TECHNICAL INSTRUCTION No. 57

Kestrel Modification No. 15

Provision For Take Off Position On The Landing Flap

MOD. TO LANDING FLAP LEVER

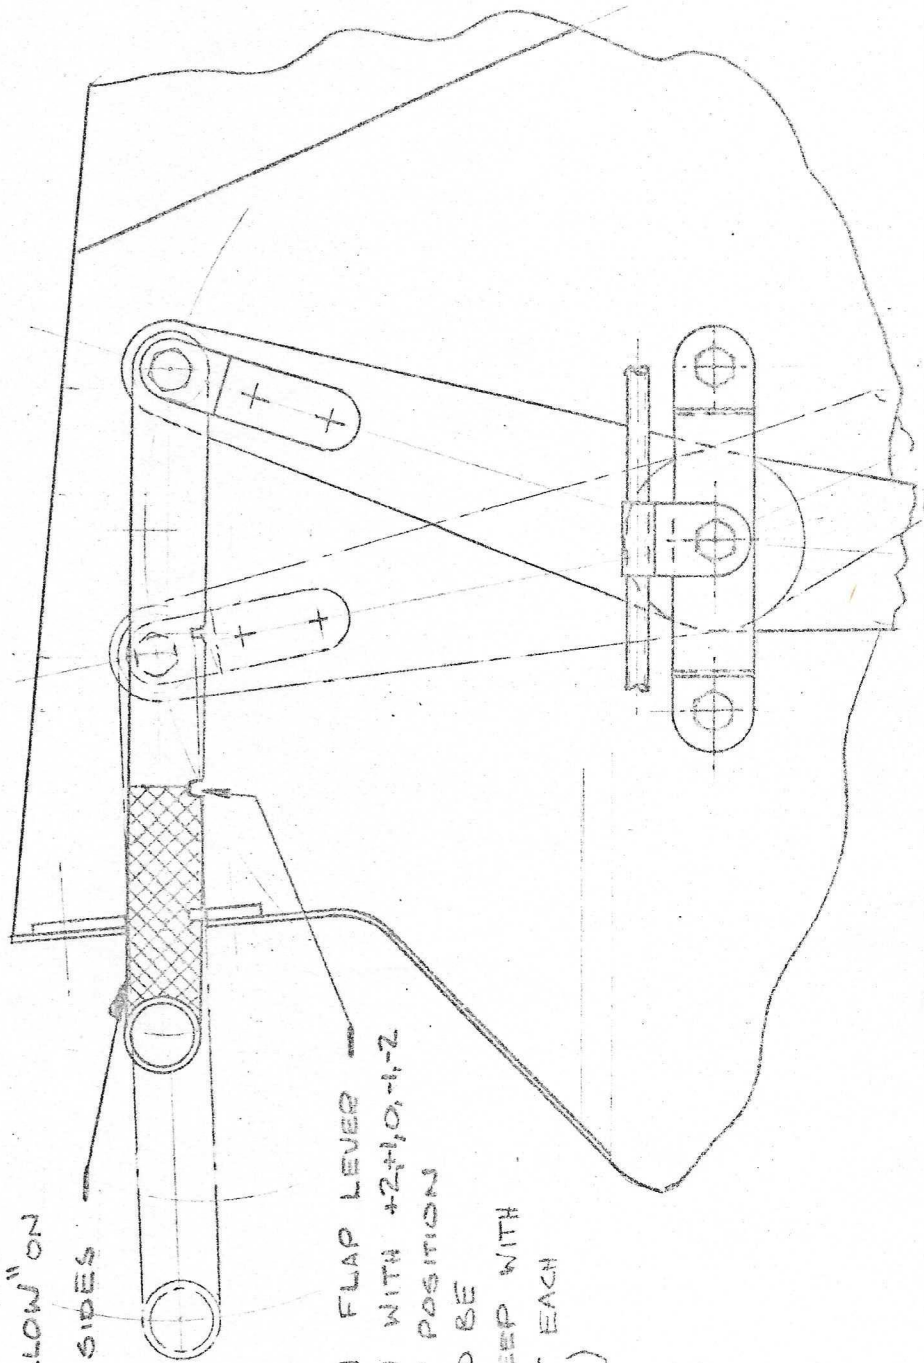
TO GIVE "TAKE OFF" FLAP POSITION

SHADED AREA TO BE  
PAINTED "YELLOW" ON  
ALL FOUR SIDES

CUT NEW SLOT IN FLAP LEVER  
TO GIVE  $14^{\circ} \pm \frac{3}{2}$  DOWN WITH  $+2H/O, -1, -2$   
FLAP LEVER IN 'O' POSITION  
(SLOT DIMENSIONS TO BE  
 $2.2 \frac{1}{4}$  WIDE X  $4 \frac{1}{4}$  IN DEEP WITH  
 $1 \frac{1}{4}$  X  $45^{\circ}$  CHAMFER AT EACH  
SIDE OF ENTRANCE)
